**DEVELOPMENT MANAGEMENT COMMITTEE**  
**18th April 2024**

**ADDENDUM SHEET**

**23/02034/MFA Hybrid planning application comprising (i) Full application for the construction of 57 dwellings (Use Class C3), (including affordable housing), 59 no. units of Extra Care accommodation (Use Class C2), means of access, landscaping, open space and all other associated works and infrastructure; and (ii) Outline planning application (all matters reserved except access) for up to 129 dwellings (Use Class C3), (including affordable housing), provision of a minimum of 1.15ha community land for outdoor sport and recreation and construction of community buildings (Use Class F) including provision of scouts hut, community orchard, gardens, green space, landscaping and all other associated works and infrastructure.**

**Land At Grange Farm, Grange Farm, Green Lane, Bovington, Hertfordshire**

**Figure 1 Annotated Extract of Map 26**

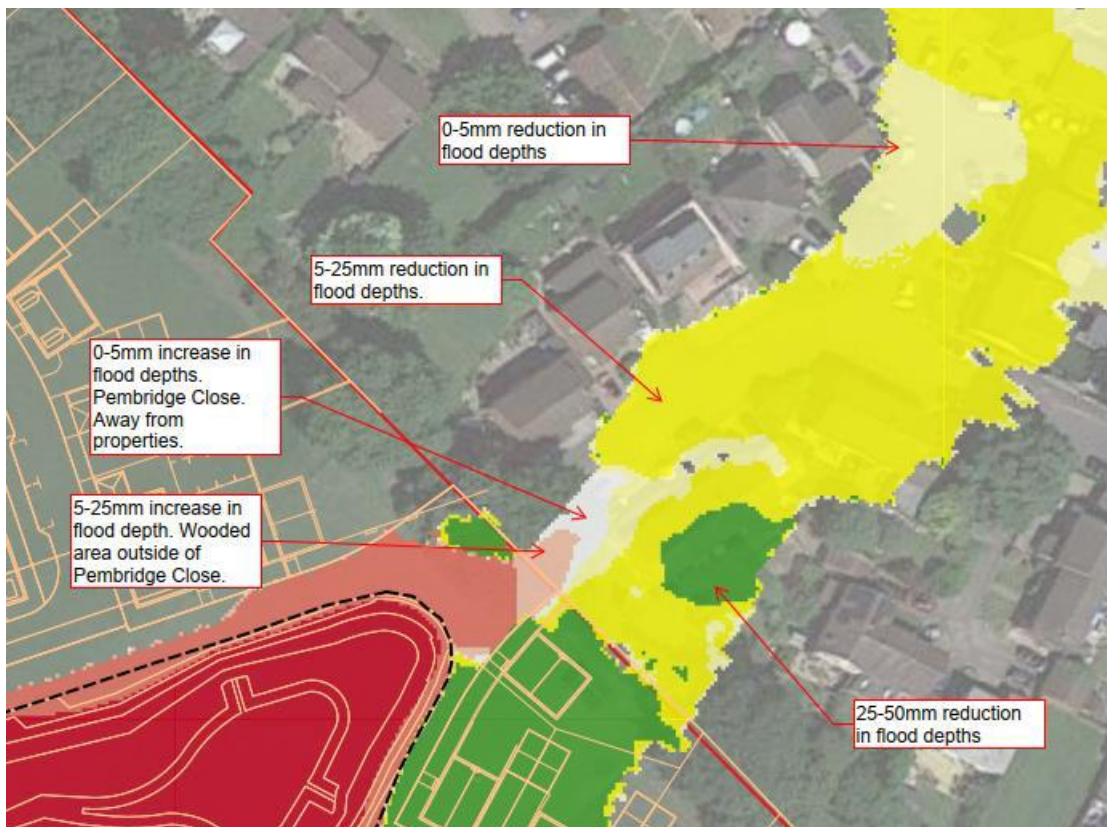
From a review of the Flood Risk Modelling report Nov 2023 by JNP, Map 26 clearly indicates an increase in predicted flood depth (of up to 25mm) across off-site areas downgradient of the site (including Pembridge Close) for the 1% AEP + 40% climate change event.

It appears that JNP, the developer's flood risk advisor, concur with my professional opinion that the proposed flood risk and drainage strategy unduly increases the risk of flooding to Pembridge Close and areas downgradient of the site.

***JNP Response:** This is incorrect, no part of Pembridge Close is shown to have an increased depth of up to 25mm. There is a very small area of woodland at the site boundary which shows an up to 25mm increase in flood depth, and an equally small area of Pembridge Close showing a 0-5mm increase in flood depth. No mention is made by DJA in the above that the vast majority of areas downstream show a reduction in flood depths including the areas closest to existing properties. See marked-up extract of Map 26 below.*

*This is not the conclusion made within the JNP Flood Risk Modelling report. Paragraph 5.1.8 "Modelling shows that the development and its water management infrastructure will reduce the amount of flood runoff leaving the site at its eastern boundary compared to existing conditions during a design storm event (1% AEP with 40% climate change adjustment) by a small amount. Flood outflow will be significantly reduced by the developed site during more frequent less severe events."*

The very minor increases in flood depth, outlined in the figure above, are a result of the redirection of flows away from existing properties, this is a clear betterment of the existing situation.
